ASUS® P4T Update

Modifications to the motherboard CPU mounting assembly on pages 25 to 29, Section 3, Hardware Setup.

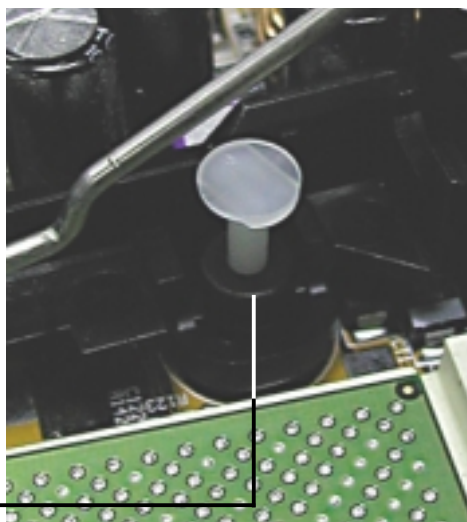
If your P4T-M does not have the *rubber* and *metal baseboard mounting plates*, please follow these instructions. The baseboard installation step on page 26 is omitted. Since the CPU heatsink mount is modified, new parts for mounting the heatsink assembly are pictured here. The black plastic *heatsink support braces* have built-in *retaining clips*, right. The *pan head screws* are replaced with a new two-piece *plastic collar and plug* assembly, below.

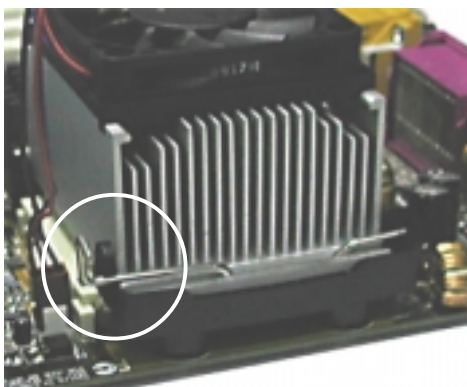
1. Mount the CPU as shown on page 27. Mount the *heatsink support braces* as shown on page 28 and insert the four black *plastic collars* from the top through to the bottom of the motherboard. Insert the white *plastic plugs* into the middle of the black collars and pop them firmly out the bottom of the motherboard.

2. Open the retaining clips, place the heatsink on the CPU, then close and snap the clips into the locked position.
